GROUP	MODEL
CLI	2021-2022MY K5 (DL3a)
NUMBER	DATE
056 (Rev 1, 9/17/2024)	August 2024

TECHNICAL SERVICE BULLETIN

HEATING, VENTILATION, AND AIR CONDITIONING (HVAC) BLOWER MOTOR FUSE RELOCATION (WTY037)

This bulletin provides information associated with the 'Warranty Extension Program' (WTY037) to inspect, and if necessary, relocate the Heating, Ventilation, and Air Conditioning (HVAC) blower motor 40-ampere fuse on certain 2021-2022MY K5 (DL3a) vehicles produced from March 27, 2020 through July 20, 2022. The HVAC system provides cooling and heating to help maintain a comfortable environment inside the vehicle. The blower motor provides primary airflow for the HVAC system. Extended use of the HVAC at high fan speeds may cause damage to the multi-fuse terminals for the HVAC blower motor circuit, which can cause the blower motor to become inoperative, resulting in reduced heat and air conditioning. The warranty coverage for repairs related to the HVAC blower motor have been extended from 5 years / 60,000 miles to 15 years / 180,000 miles, whichever comes first, starting from the date the vehicle was first put into service. Follow the procedure outlined in this publication to relocate

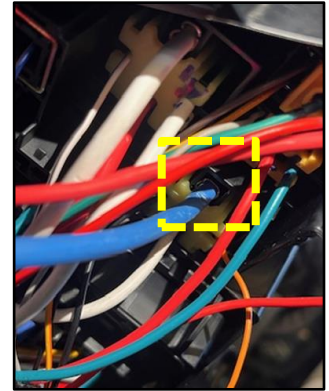
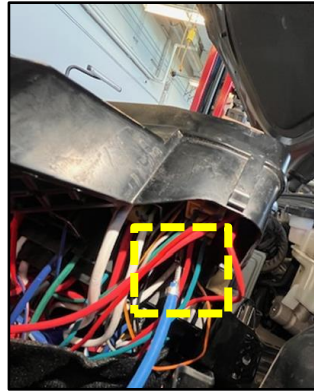
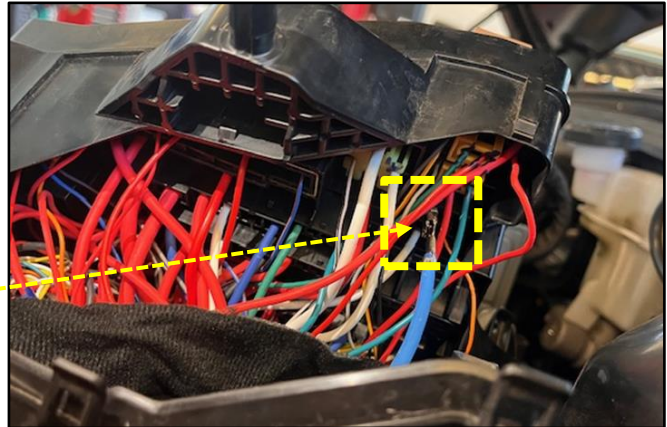
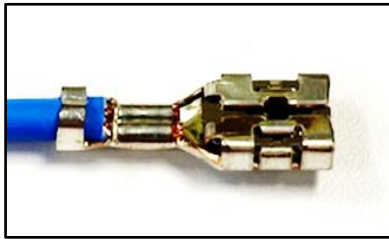
13. Using a pick/awl, disengage the wiring pin (P) release tab from the multi-fuse (K) #3 position on the junction block (L).

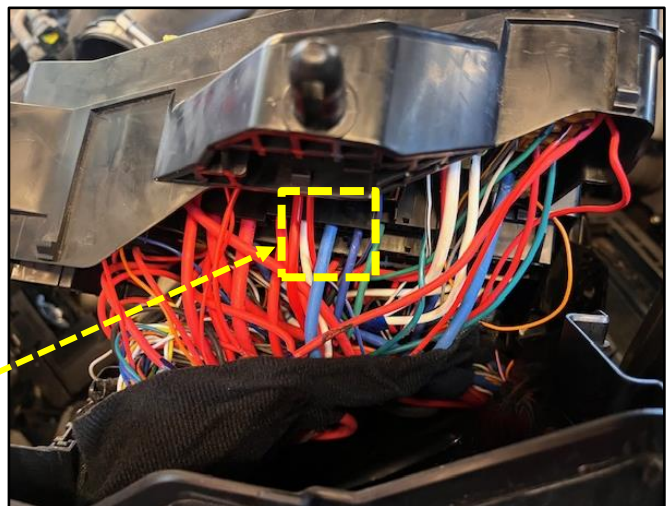
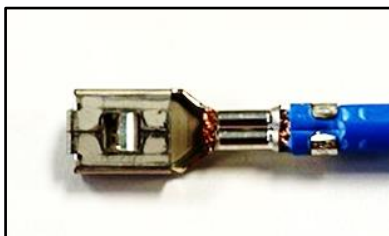
14. Install one end of the new wire in the blower motor relay (I) position on the junction block (L), as shown.

15. Insert the other end of the new wire in the multi-fuse (K) #6 position on the junction block (L), as shown.

Note: Ensure that the new wire is secured behind the fabric tape, as shown.
